REMARKS

Claims 1-25 are pending in the present application. The Examiner has rejected claims 1-7, 9-13, and 15-25 and objected to claims 8 and 14. Further, the Examiner has objected to the drawings and the specification of the applications. Applicants have amended the drawings and specification as indicated by the Examiner. Further, Applicants have amended claims 1 and 19 to clarify the invention and claims 8 and 14 as suggested by the Examiner. No new matter has been added by these amendments.

Fig. 1 (Prior Art)

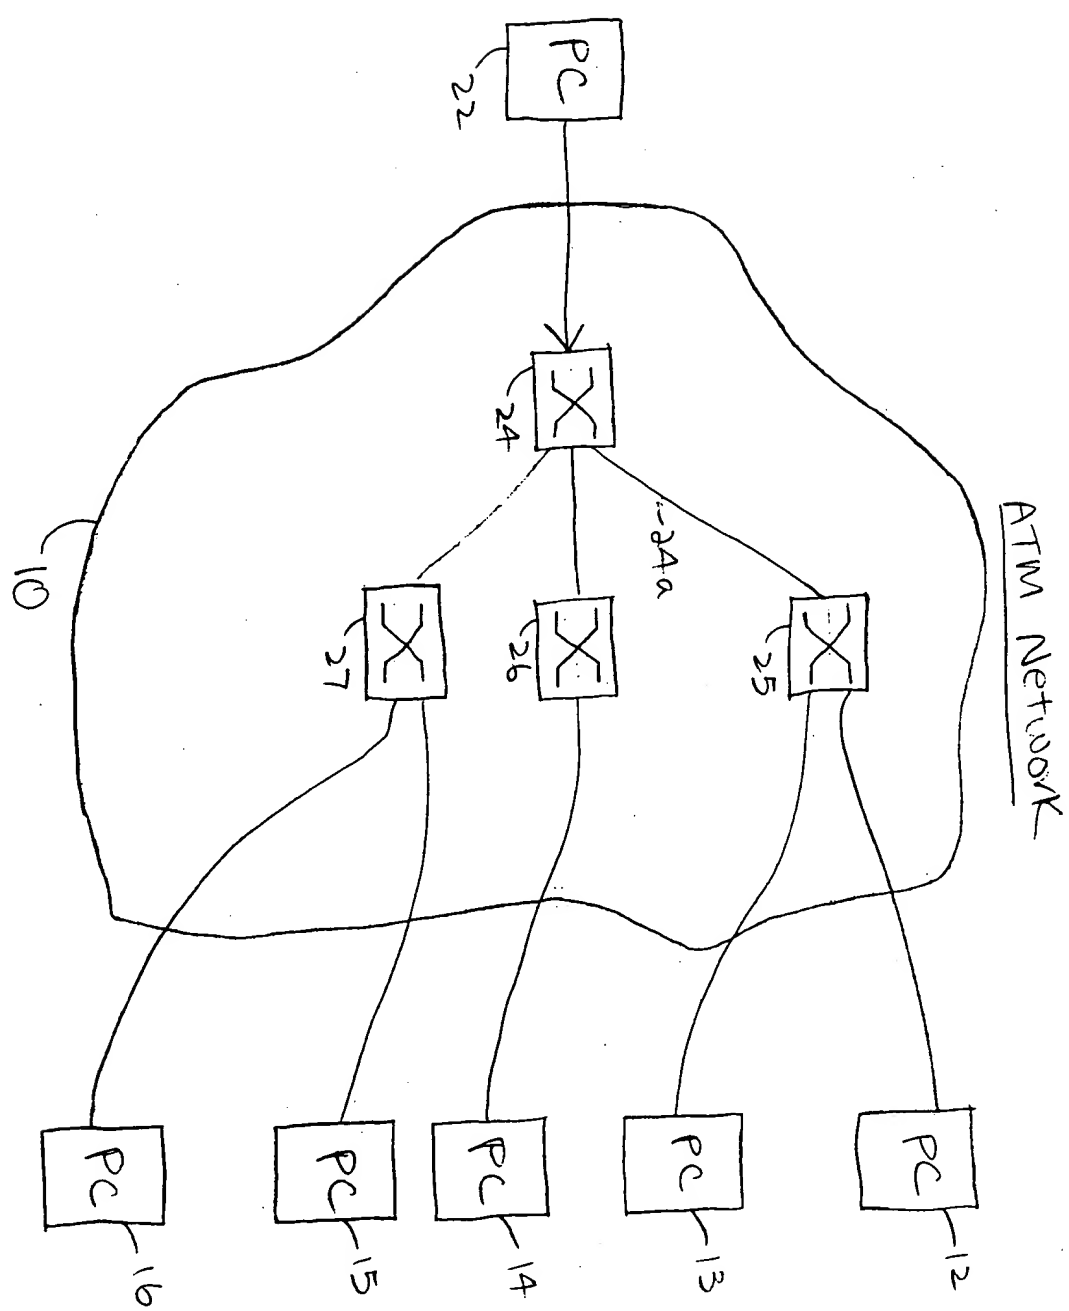
The Examiner has objected to the drawings. In particular, the Examiner has indicated that Figures 1-4 should be labeled with the legend --Prior Art-- "because only that which is old is illustrated." Further, the Examiner has indicated that Figure 1 includes a reference sign, sign "24a," that was not mentioned in the description. Also, the Examiner has indicated that the description describes a reference number 34 that is not included in the Figures.

As indicated above, Figures 1-4 have been amended to include the legend --Prior Art--. Further, Figure 2 has been amended to include indication of element "34." The reference to element 24a of Figure 1 is included in the specification on line 6 of page 20; therefore, no amendment to Figure 1 with respect to the element "24a" is made.
